Duquesne Light

Reference: Beaver Valley Power Station, Unit No. 1
Docket No. 50-334, License No. DPR-66
RHR Heat Exchanger Nozzle Relief Request

APPLICATION FOR RELIEF OF
INSERVICE INSPECTION REQUIREMENTS

RHR Nozzle Relief Request

Figure - C1.2

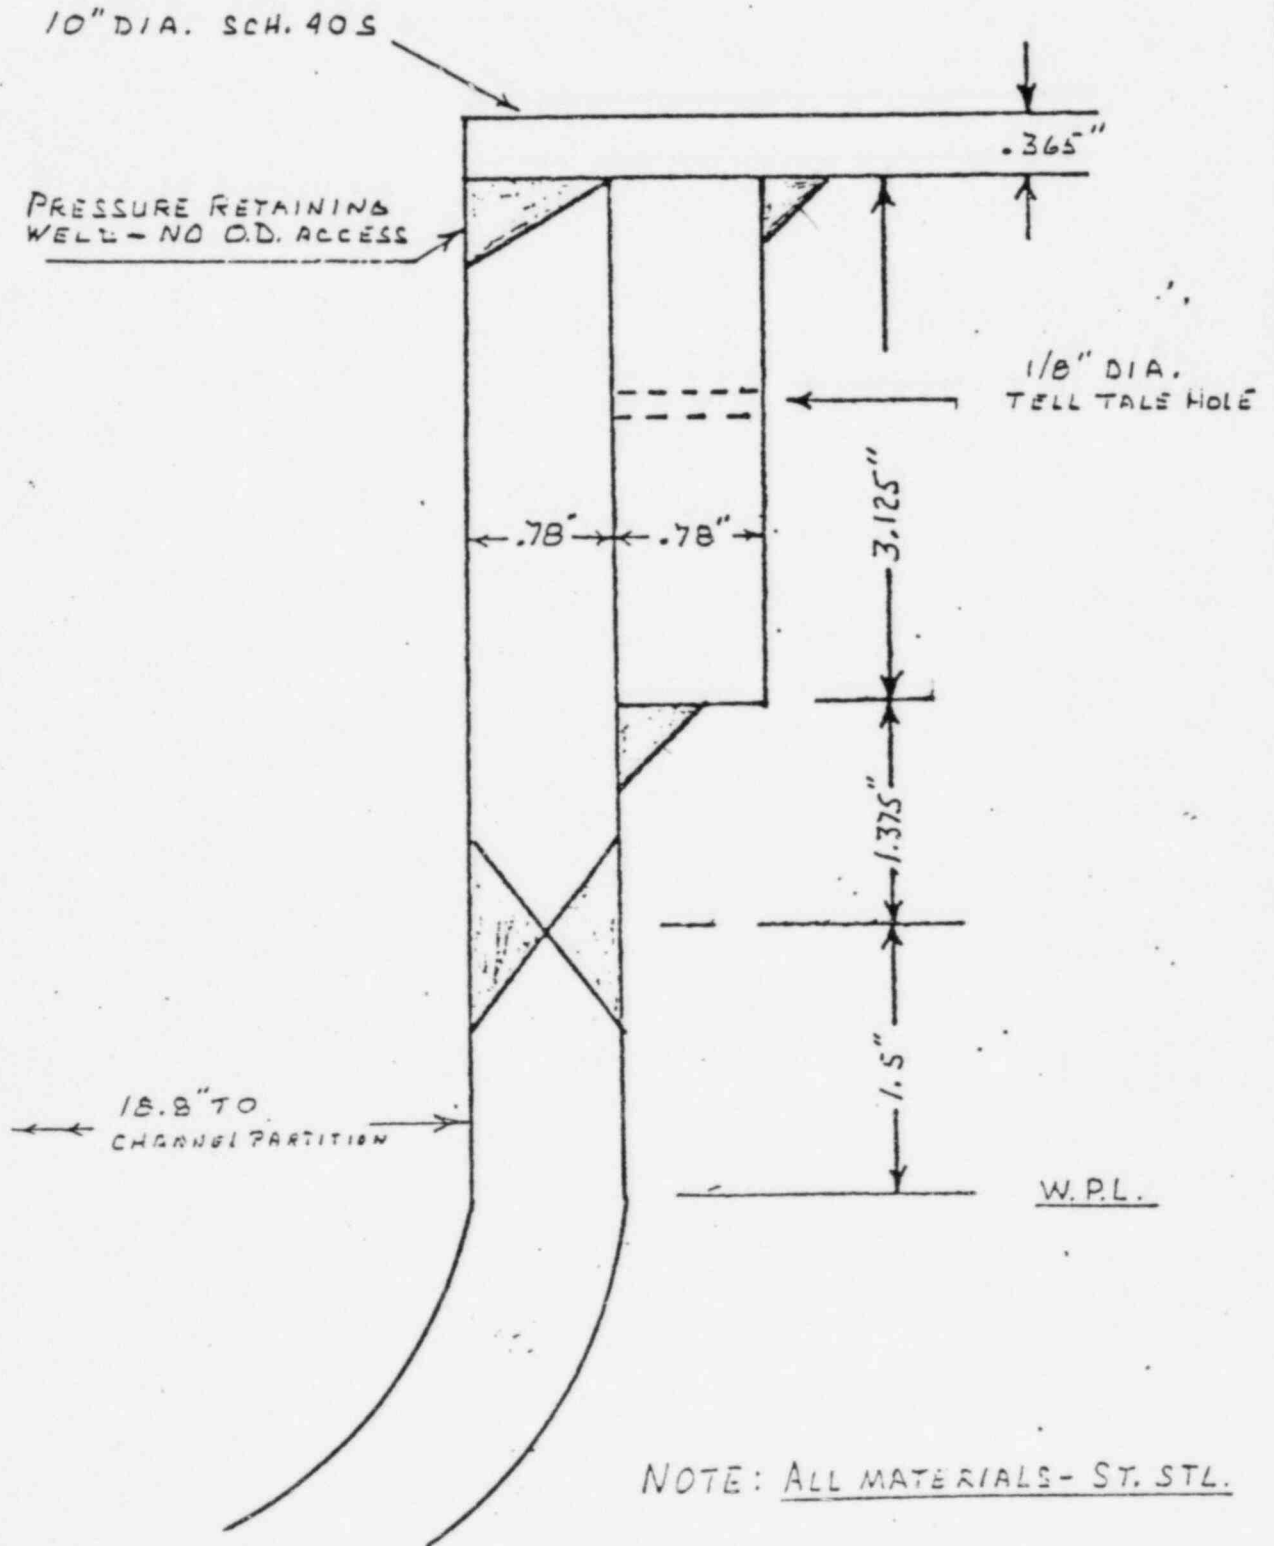
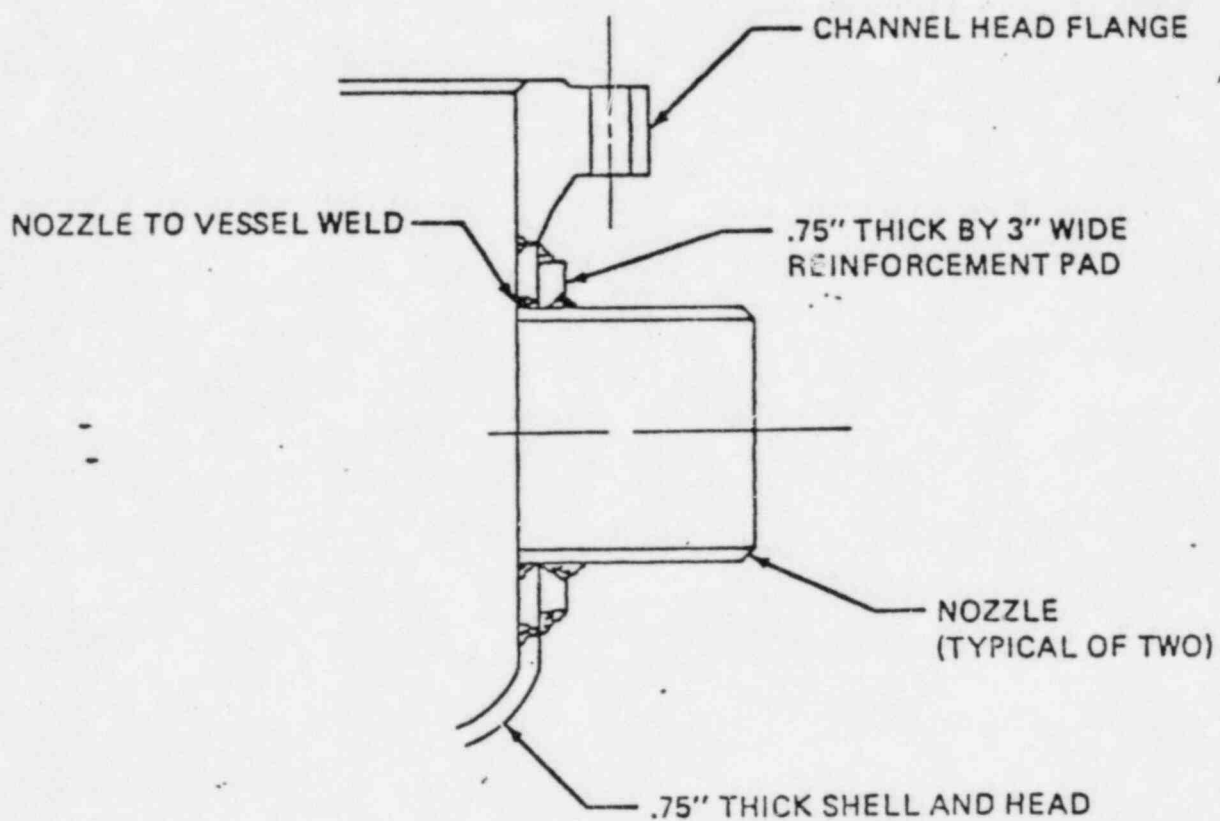
The residual heat removal heat exchanger nozzle to vessel weld is covered by a reinforcement ring and is not accessible for examination as required by IWC-2600.

- a. An anticipated high radiation work environment.
- b. The weld geometry will likely yield only a partial examination (see Attachments).
- c. The examination surface area has not been prepared for ultrasonic examination.
- d. Surface preparation via grinding and/or polishing would significantly increase the man-rem exposure and create a severe problem in maintaining the system cleanliness requirements.
- e. The material to be examined is austenitic stainless steel. Austenitic materials display anisotropic properties and are inhomogeneous in nature leading to the anomalous behavior of the sound beam as it passes through the material. Viable ultrasonic examination procedures of this material have not been developed to the satisfaction of the ASME Code Committees.

Visually examine the nozzle reinforcement ring area (including the telltale hole) for evidence of leakage and degradation once each Code period (40 months). In addition, perform a surface examination of the reinforcement ring weld surfaces once during each Code period (40 months).
